A d d e n d u m

Iowa Department of Transportation
Office of Contracts

Date of Letting: April 17, 2012
Date of Addendum: April 12, 2012

B.O.	Proposal ID	Proposal Work Type	County	Project Number	Addendum
00A	78-0293-080-M	BRIDGE NEW - STEEL GIRDER	POTTAWATTAMIE	IM-NHS-029-3(80)52--03-78 IM-NHS-029-3(81)52--03-78 IM-NHS-029-3(86)52--03-78 IM-NHS-029-3(87)52--03-78 IM-NHS-029-3(94)52--03-78 IM-NHS-029-3(95)52--03-78	17APR00A.A02

PILE UPLIFT ANCHOR DETAIL AT PIERS

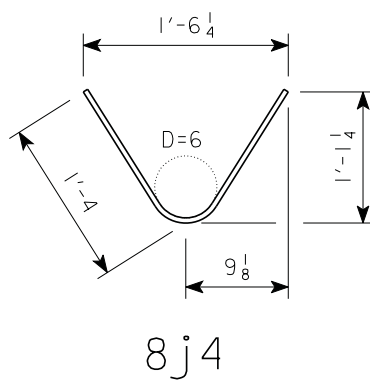
Replace Detail C and Section E-E with Pile Uplift Anchor Detail at Piers.

Replace 24 - 9f6 bars with 36 – 8f7 bars and quantity changes from 490 lb. – 481
lb. Reinforcing Steel – Totals change from 38,724 to 38,715

PILE UPLIFT ANCHOR DETAIL AT ABUTMENTS

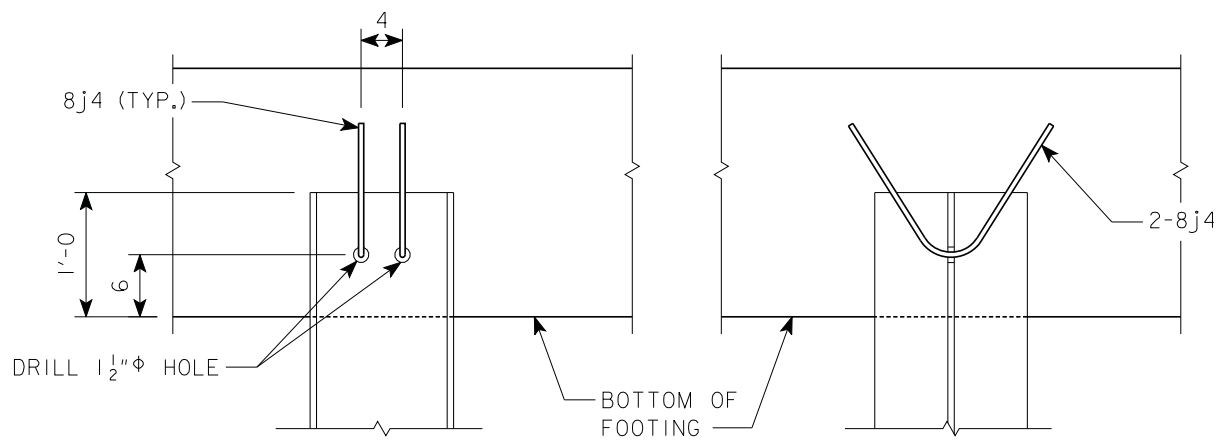
Replace Detail I and Section G-G with Pile Uplift Anchor Detail at Abutments

Replace Detail I and Section G-G with Pile Uplift Anchor Detail at Abutments

DETOUR 299

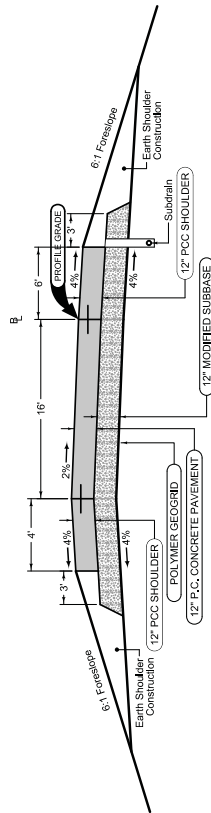
Change pavement width from 14' to 16'
